Appearance Commission - CANCELLED

APPLICANT	Edward Davies on behalf of Target
ACTION REQUESTED	Approval of landscape plan
ADDRESS	17605 Halsted
PIN	29-33-100-064-0000

PRELIMINARY SITE/LANDSCAPE PLAN REVIEW

T1460 Homewood Appearance Commission Materials
Target Front Walk and Exterior Site Sustainability Program

IMPROVEMENT PLAN

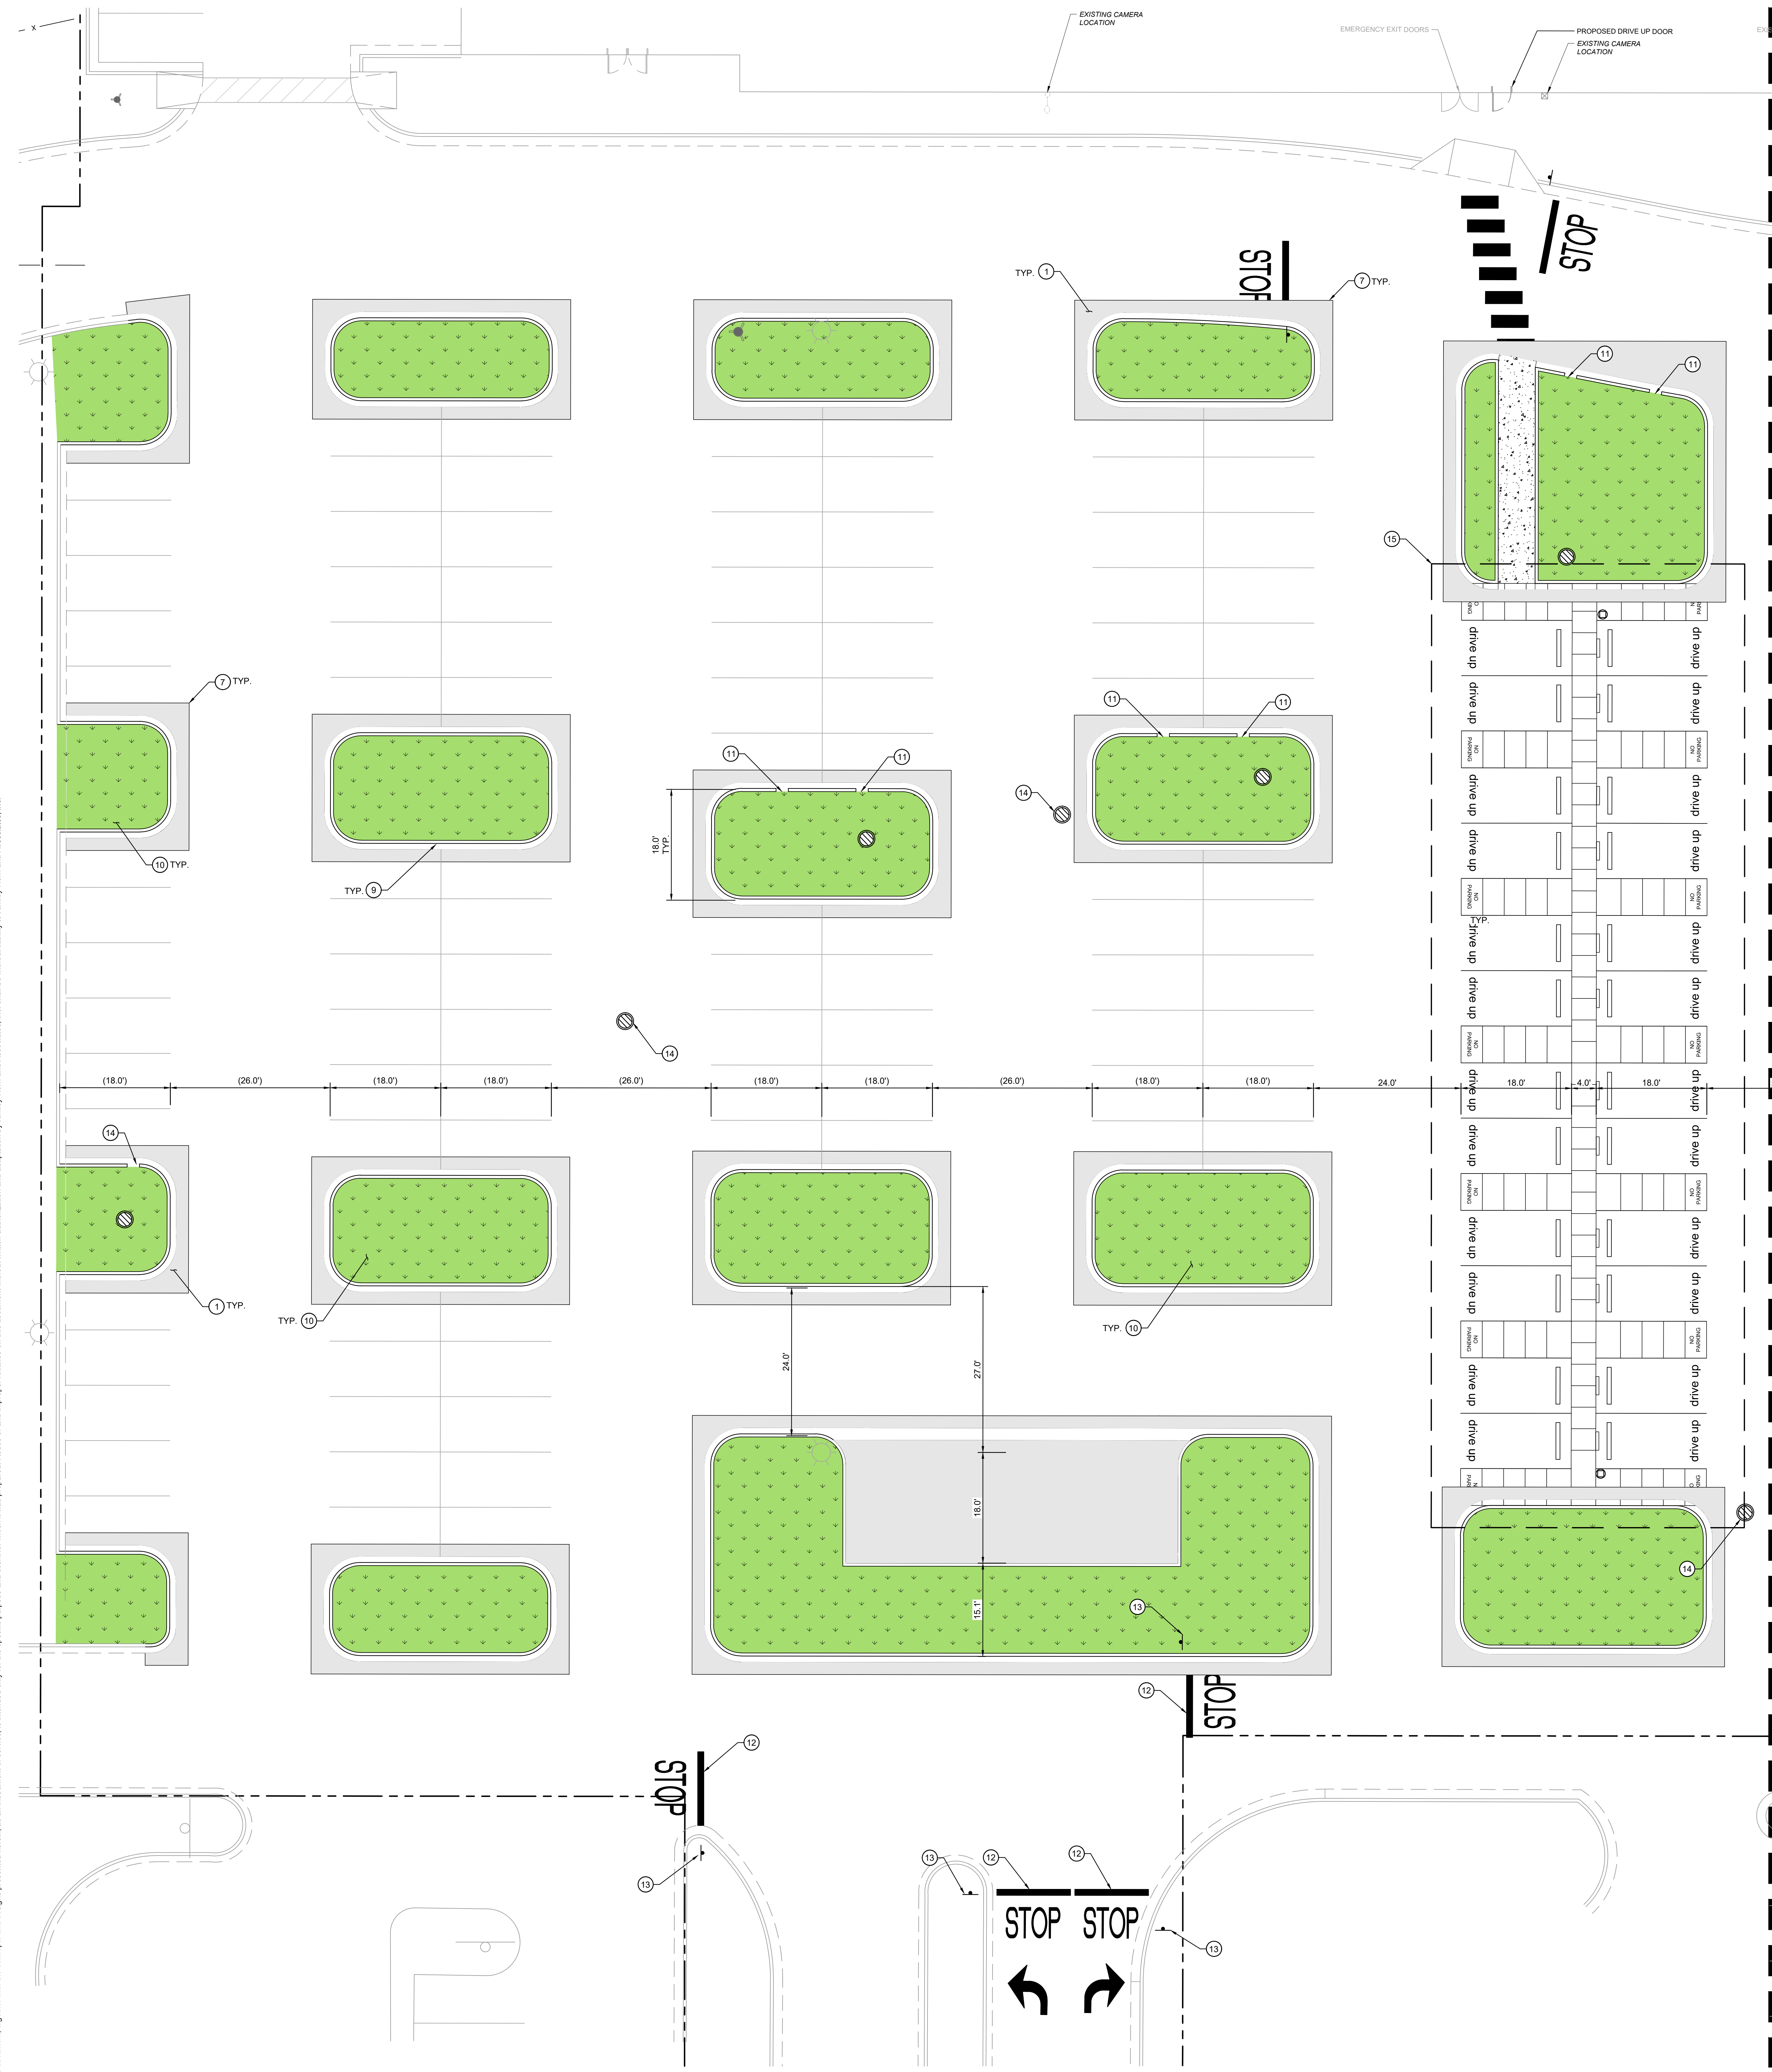
14. Coordinate the civil and engineering sheets. Sheet C200 shows benches and trash receptacle at the store in a line weight indicating new work. Sheet L101 calls for these site furnishings to be removed. Indicate areas of new work at the walkway on C200.
15. Title of sheet C200 is misspelled.
16. Bicycle racks should be installed in accordance with the NACTO or APBP standards. Provide dimensions demonstrating compliance with these best practices.

XSS EXISTING
 CONDITIONS -
 DEMO PLAN

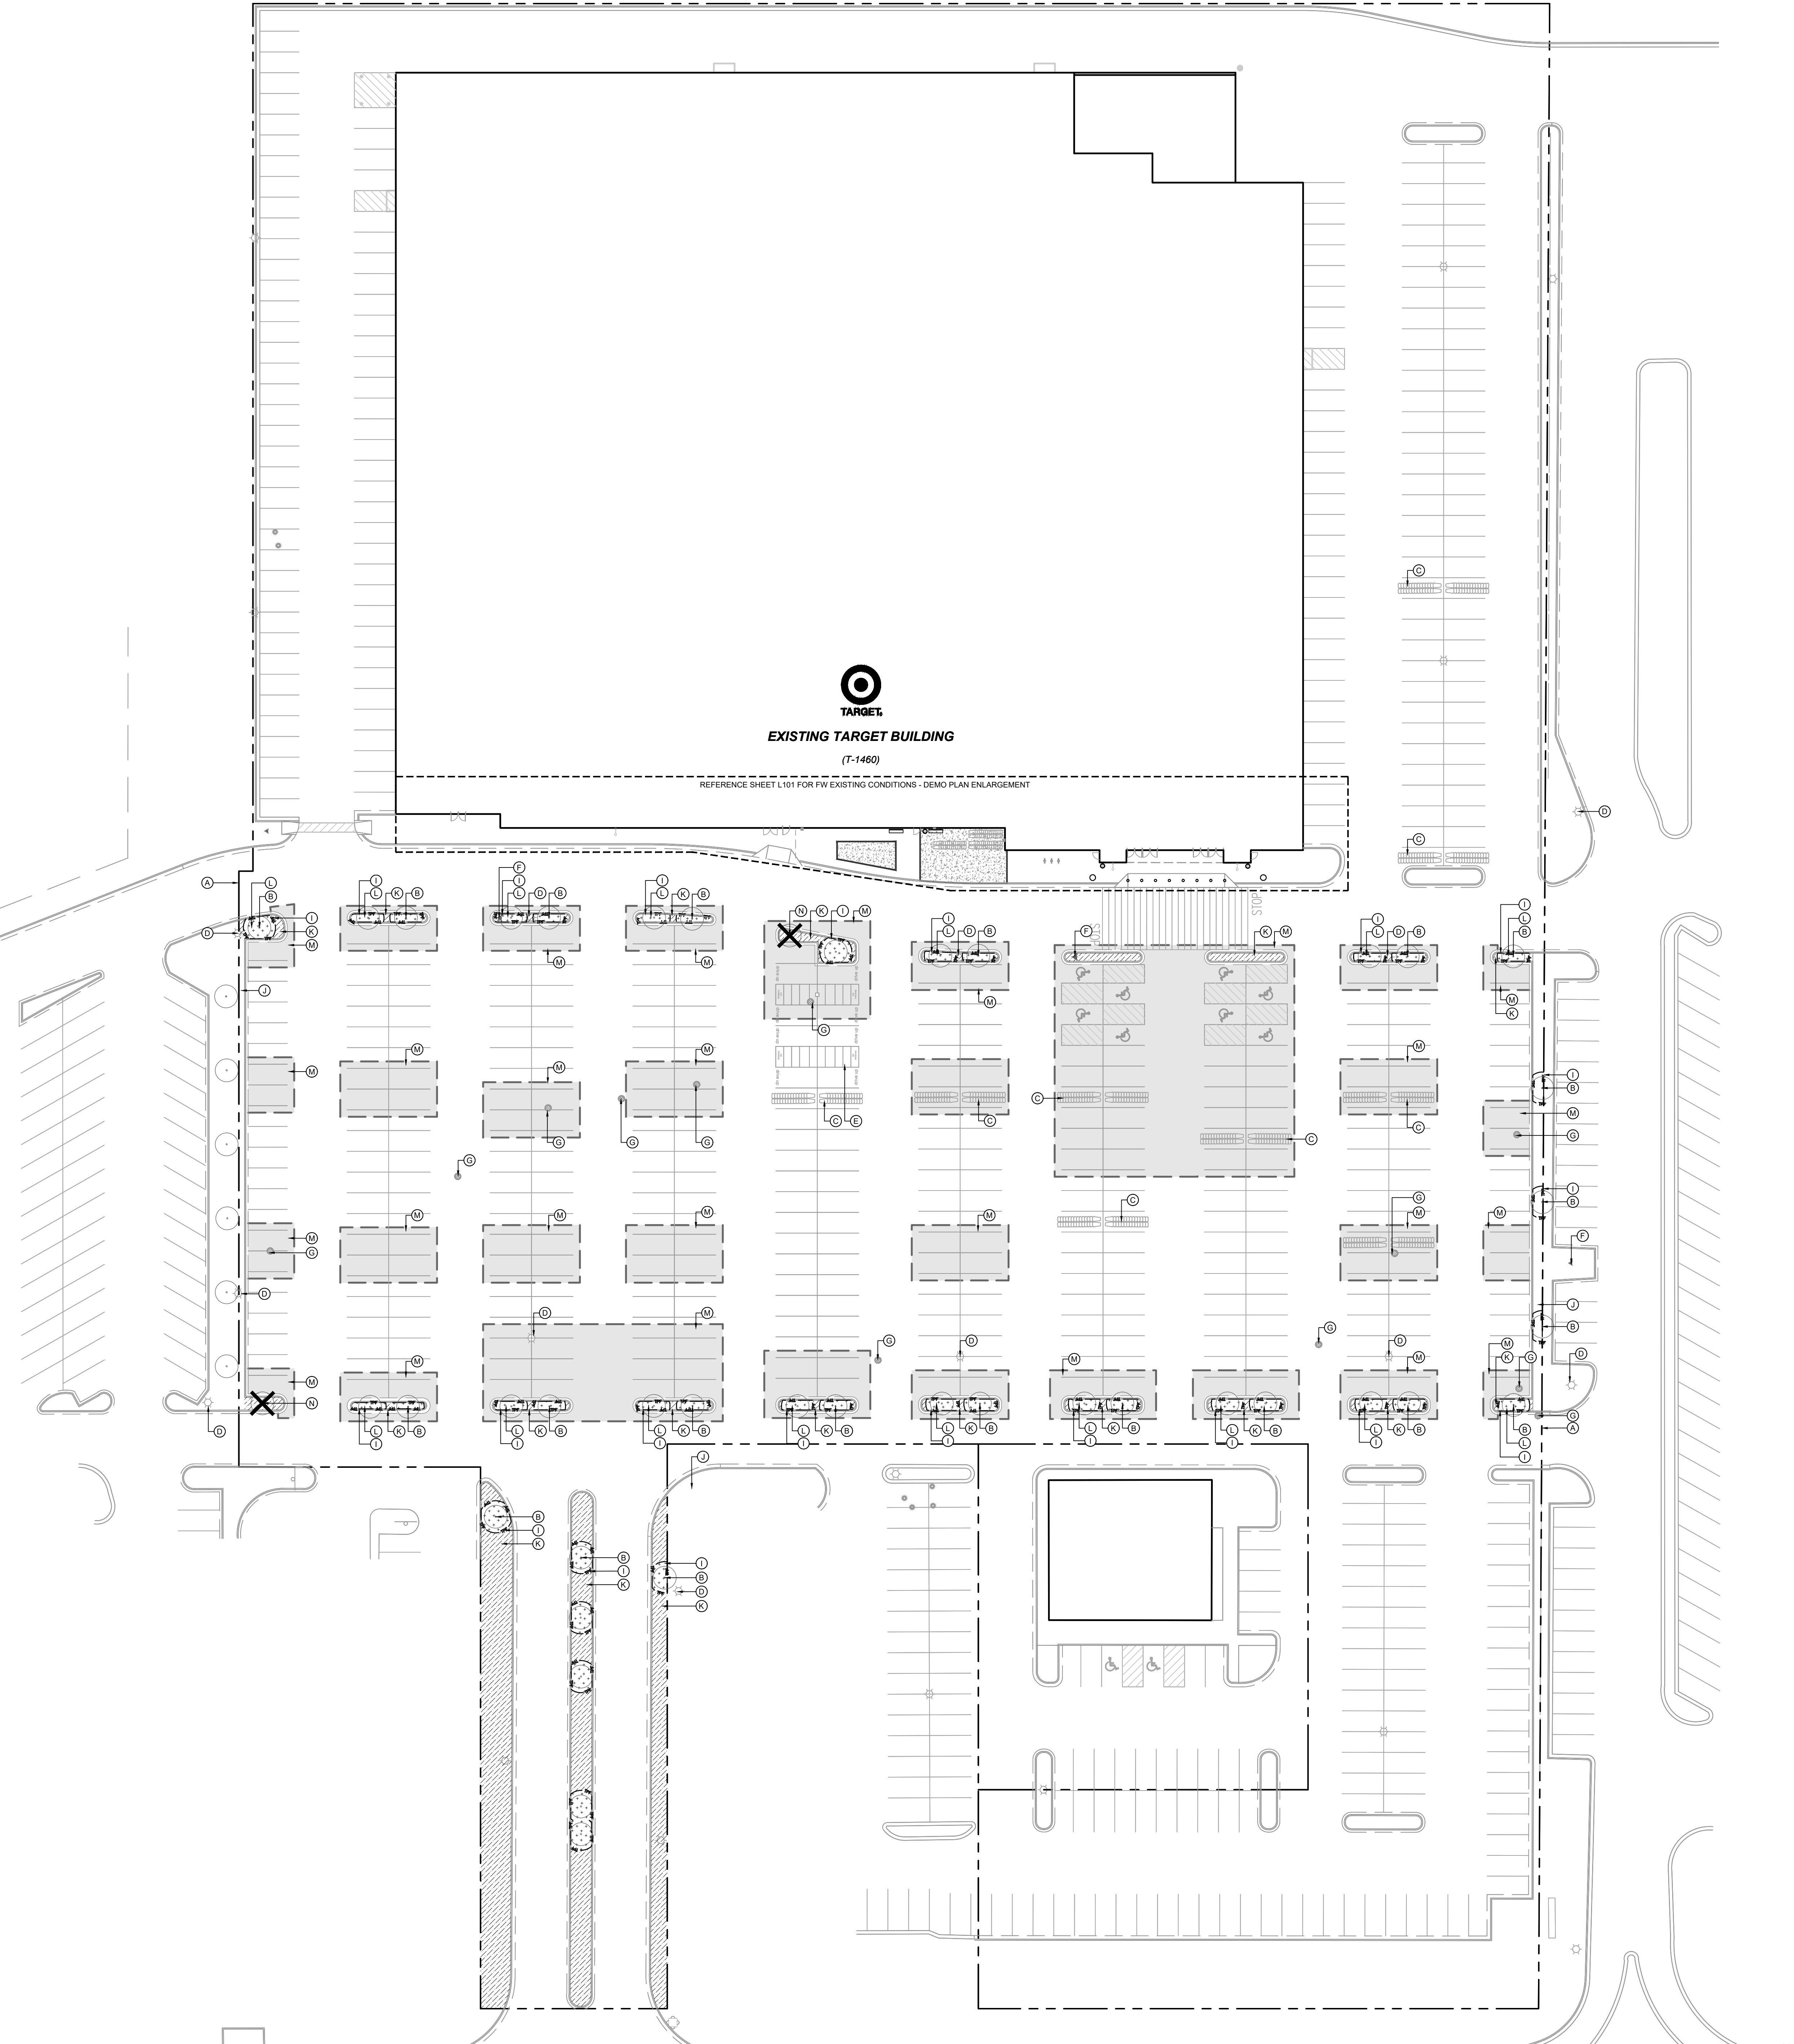
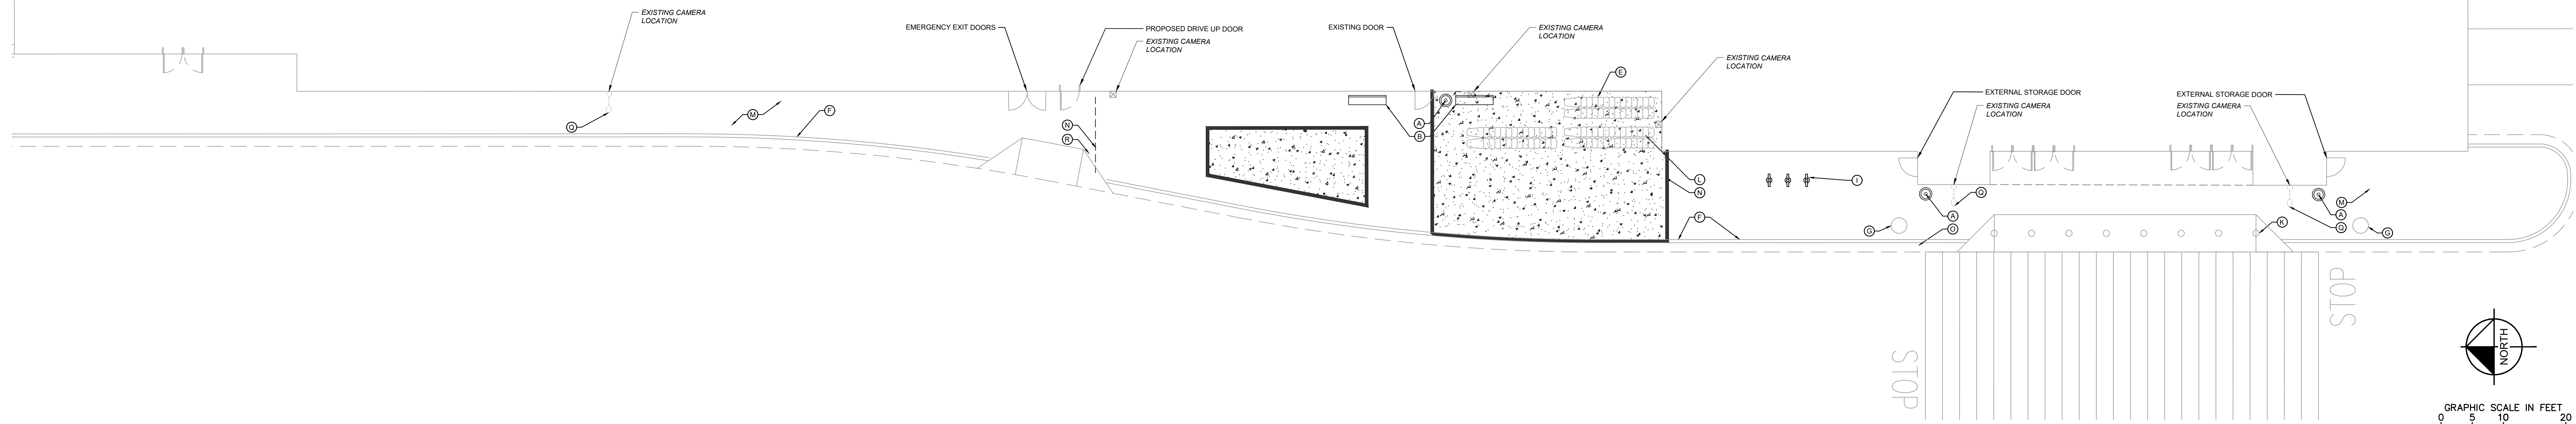
The landscape plan appears to indicate some existing trees remain. These are not identified in the plans. The Village Arborist has noted that these are oak trees that are very susceptible to soil disturbances. Staff request that the applicant provides a list of the existing trees, indicating those to be removed and those to remain for further review.

9. Provide a list of all existing trees. Indicate which are to be removed and which are to be retained.
